May 4, 2026

RE: Johnson Tract Project Reclamation Plan Approval Amendment #1(A20243253RPA.01) – Proposed Reclamation for the Portal Closure, Dewatering Pipeline, and Rapid Infiltration Basin (RIB)

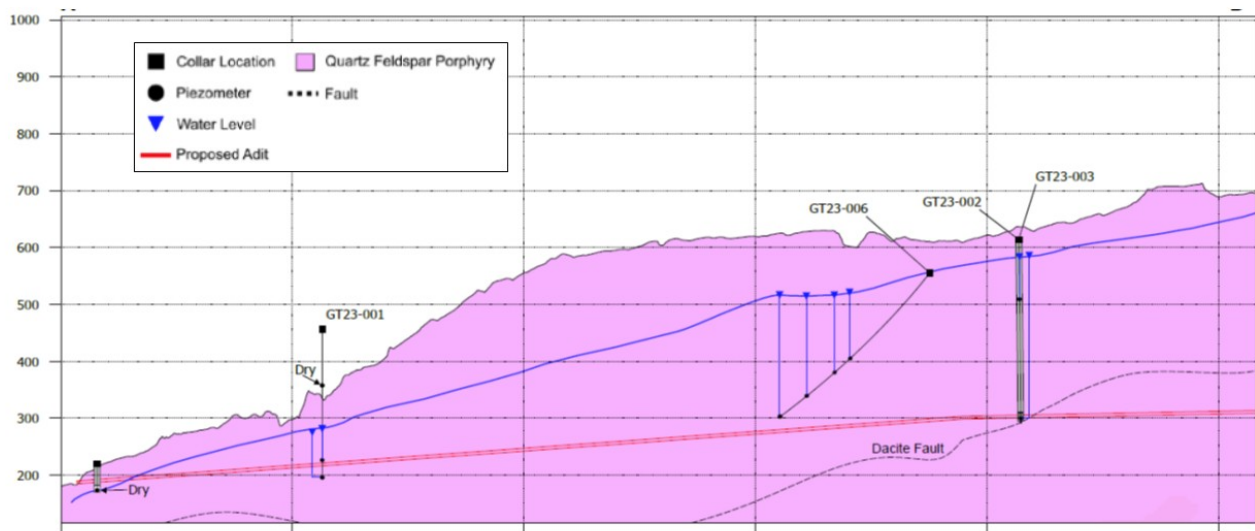
- Inconsistently depicting the location of boreholes GT23-002 and GT-003, which were used to predict adit water quality (locations are different in Piteau (2023) vs. Piteau (2025) reports).

The two reports with groundwater quality results are the Piteau Associates (“Piteau”) 2023 and 2025 reports. The source term report²³ used groundwater quality results from Piteau 2025.²⁴ Only two locations were used: GT23-002, at a lower elevation of 289 m amsl (265 m below ground surface (bgs)) near the proposed adit, and GT23-003, at a higher elevation of 582 m amsl (32 m bgs) near the water table.²⁵ Both locations appear to be in the same borehole at different depths, as shown in Figure 3, but a similar diagram in Piteau²⁶ shows them as two separate boreholes next to each other. In either case, using only two samples, only one of which is near the proposed adit, does not represent the potential variability in groundwater quality along the length of the proposed adit.

Figure 5 - Cross section showing the location of boreholes. Note that the Dacite Fault appears to cross the proposed adit at or near borehole GT23-002. The orebody (not shown) is located to the right of the diagram near the upgradient end of the proposed adit, and the portal would be on the left end of the diagram.²⁷

Figure 6 - GT23-002 hydrograph. Groundwater elevation trends in the deeper borehole used for water quality predictions.⁴¹

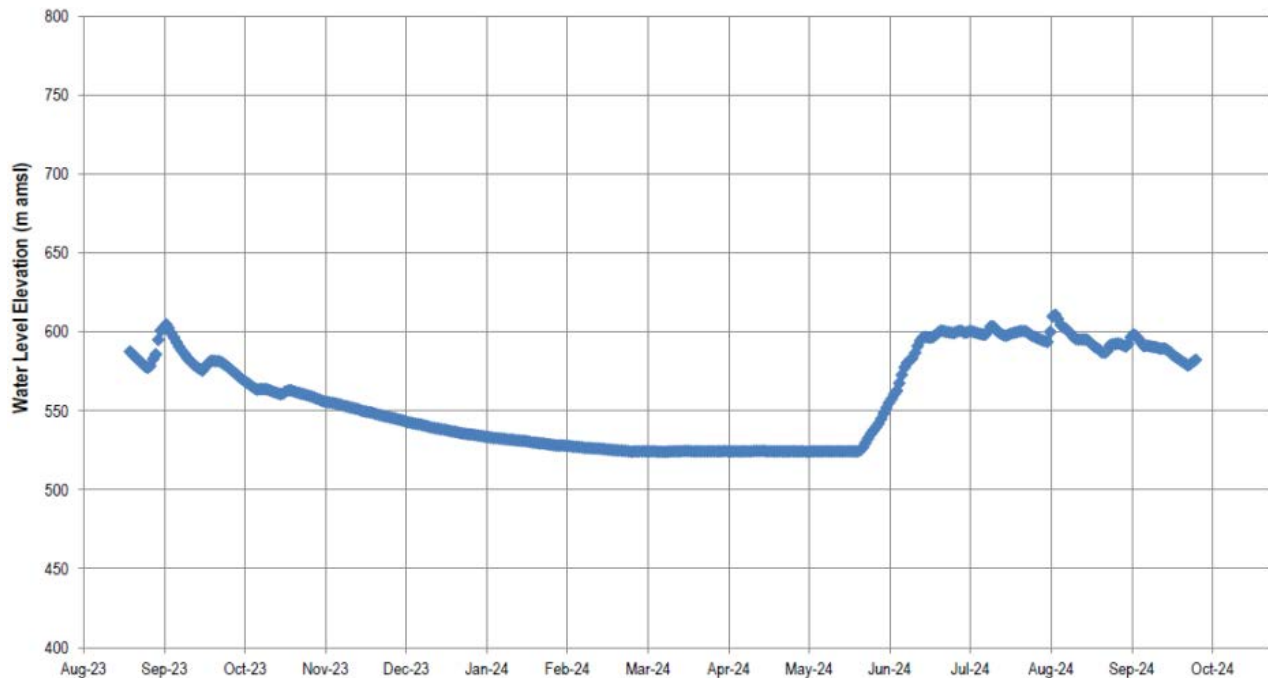
Further, the Amendment states “Hydrogeological investigations indicate that the tunnel is expected to remain dry to approximately 300 feet from the portal entrance (Piteau, 2025).” However, the Piteau report cited does not include any information on where the tunnel would remain dry – and in fact does not mention the tunnel, the portal, or the portal plug at all.

Figure 7 - Cross section showing the proposed exploration adit and static test sample locations.⁴⁶

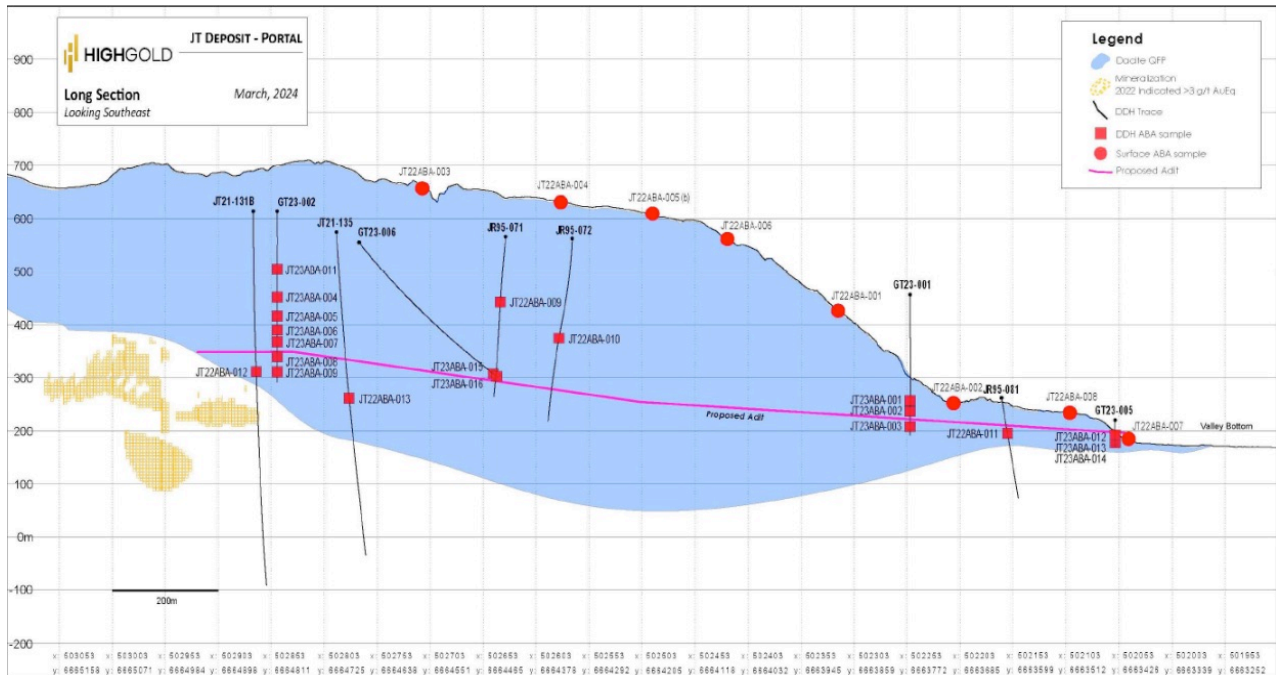
The JT deposit, as identified in 2022, is shown in gold on the left side of Figure 6. All samples were collected in the QFP unit of the Talkeetna Formation. Fifteen drill core samples collected in 2023 and five in 2022 were considered representative of potential waste rock from the proposed exploration adit: JT23ABA-001 – JT23ABA-009 and JT23ABA-011 – JT23ABA-016 in 2023 and JT22ABA-009 – JT22ABA-013 in 2022. In fact, many of these 20 samples are located at a distance from the adit itself, which is estimated to have a radius of approximately 5 meters.⁴⁴ For example, eight samples (JT22ABA-001 to JT22ABA-008) were collected in 2022 that, according to pHase,⁴⁵ are representative of the proposed exploration adit, but as shown in Figure 6, only three are close to the adit (JT22ABA-002, -008, and -007), with JT22ABA-007 being at the adit entrance.

The highest percent sulfur in the samples collected was 0.107% in sample JT22ABA-005. This value and the arsenic concentration were considered anomalously high by HighGold,⁴⁷ and another sample, JT22ABA-005b,⁴⁸ was collected and analyzed; this sample had lower % sulfur (0.005%) and a lower total arsenic content. If the original sample is indeed anomalous, the highest % sulfur value would be 0.027% in sample GT23ABA-008.⁴⁹ It is clear that the AP and NP of these samples are low, and taken by themselves, the ABA results suggest the rock samples would have a low potential to generate acid. But the use of outlier and anomalous categorization of samples is highly questionable, as some of the plots show that some of the concentrations identified as outliers are in fact not. Overall, these conclusions cannot be validly confirmed without more sample testing.

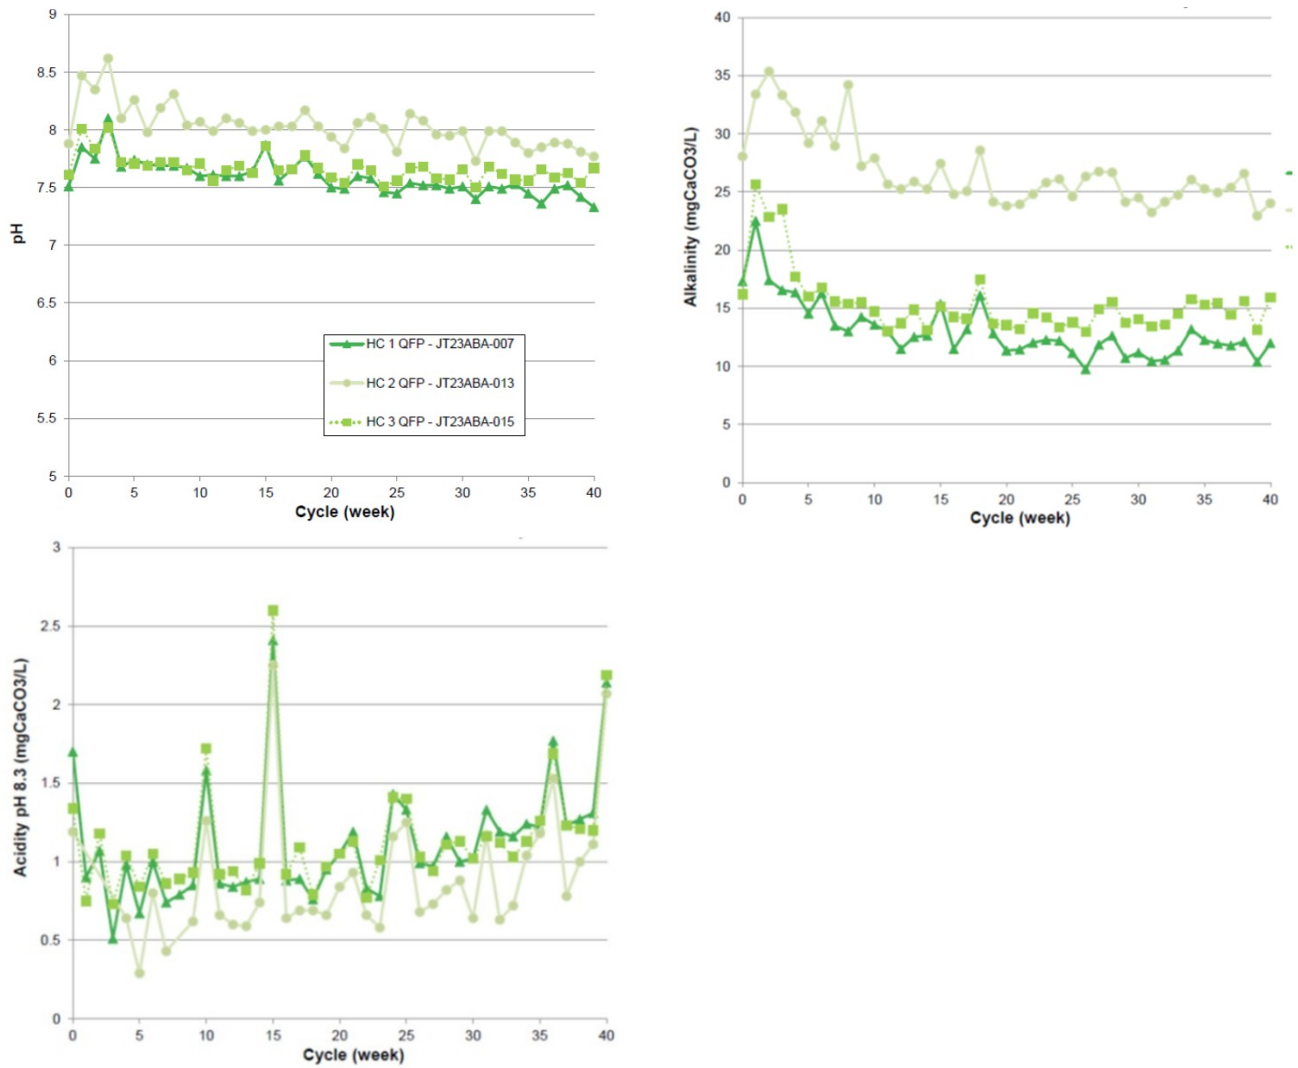
Another issue with the HCT results is that the release rates were not based on steady state values in many cases. As shown in Figure 7, pH values appear to be dropping over time for all three HCT samples. Release rates should be based on concentrations that are stable over at least the last five weeks of testing.⁵⁹ No definition of “stable” is mentioned in the pHase 2025a report, but the changes in pH values do not meet the definition in Price (2009).

Figure 9 - Variability in arsenic and manganese concentrations over time in humidity cell tests.⁶²

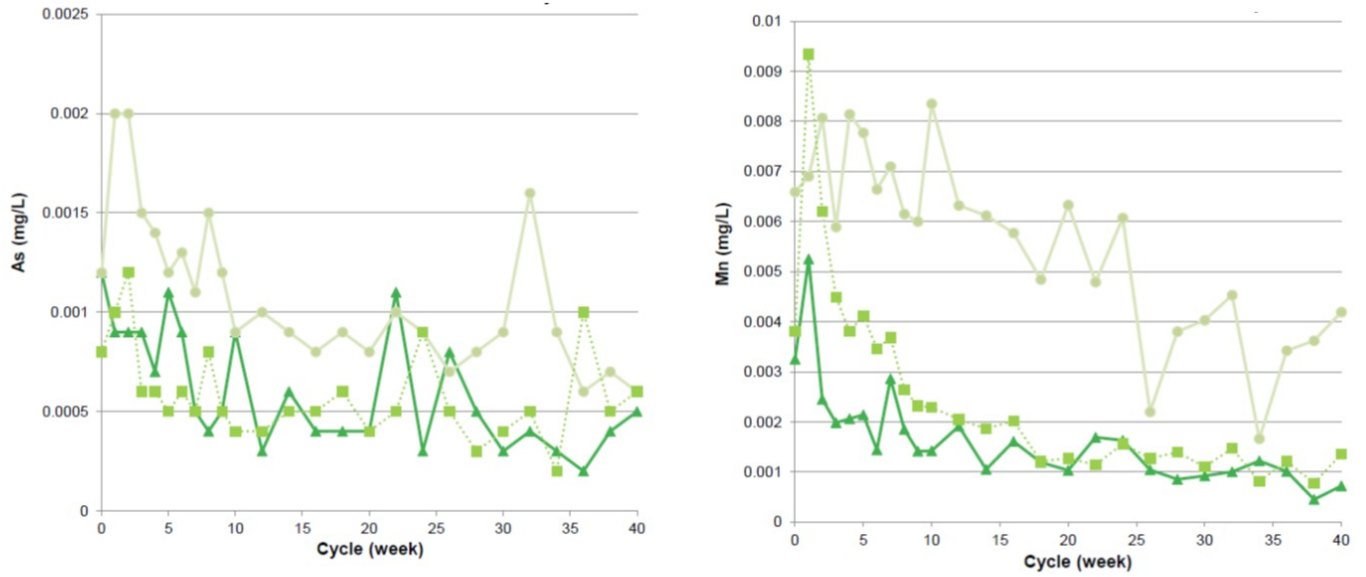
Similarly, and more noticeably, metal concentrations in the HCTs were not “stable” in most cases, yet release rates were calculated based on the variable results. Results for arsenic and manganese concentrations are shown in Figure 8, and results for cadmium and cobalt were even more variable.⁶⁰
